Polk County Zoning Commission Monday, June 27, 2022 Staff Report

JBM Acres Plat 1 - Major Preliminary Plat

Request: Preliminary Plat Approval of a Major Subdivision Plat

PRELIMINARY PLAT (MAJOR SUBDIVISION) JBM ACRES PLAT 1

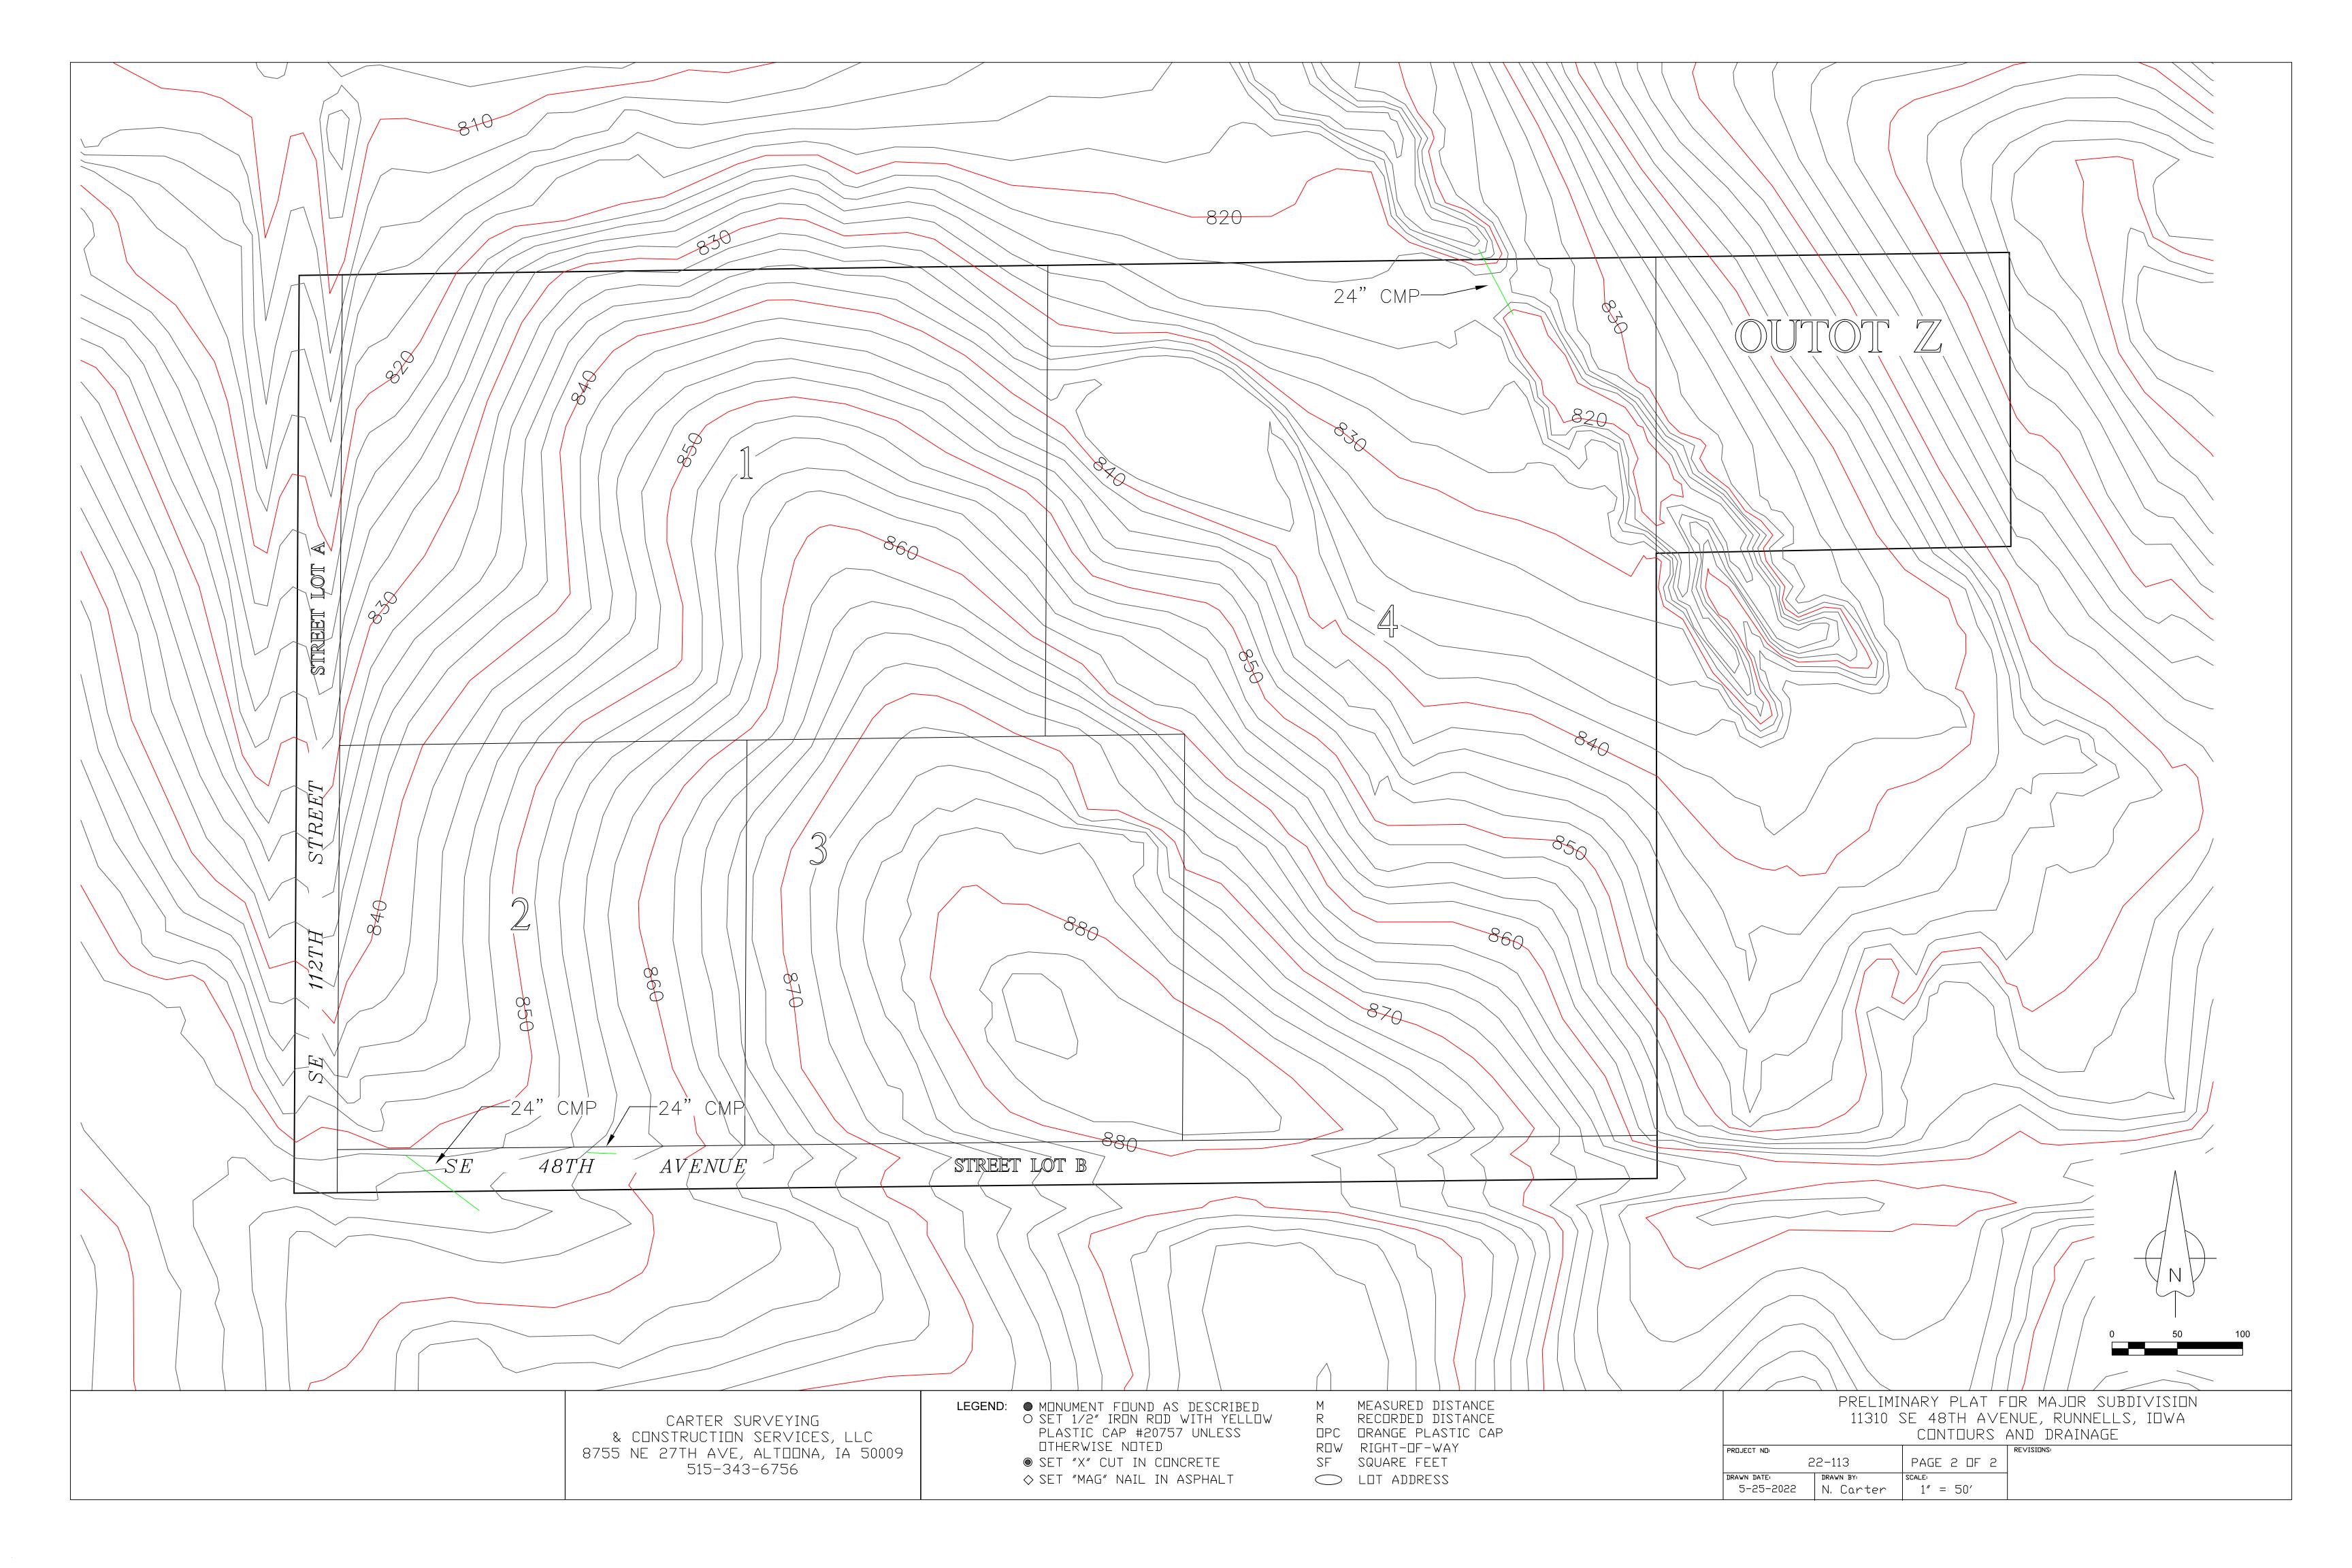
Staff has reviewed this plat for compliance with the Polk County Zoning and Subdivision Ordinances as a major subdivision plat submittal. The plat is considered a major subdivision in part because it requires a block-length waiver, as there is greater than 1,320 feet between proposed roadways. The applicant has submitted a waiver request letter, which is included with this report as *Attachment 'C'*. In summary, the applicants request the subdivision waiver because all proposed building lots will access existing public roadways without the need for flaglots, and there is no public benefit in creating additional roadways, as there is no immediate through access for traffic circulation. Lot density, dimensions, frontage, and access have been reviewed, and meet all Polk County Zoning and Subdivision Requirements. Pending approval, re-submittals will be needed in order to address staff comments. At this stage, the commission's action would affirm, deny, or amend the overall plat layout.

Staff has reviewed the layout of the proposed subdivision and the requested waivers. Due to topographic challenges on the subject property as well as properties to the north, it appears roadway extension and future development would be unlikely. Surrounding properties have also been platted in a manner which would not promote future roadways or future subdivision connectivity.

Staff recommends approval of the Preliminary Plat of JBM Acres Plat 1, as well as the requested block length waiver.
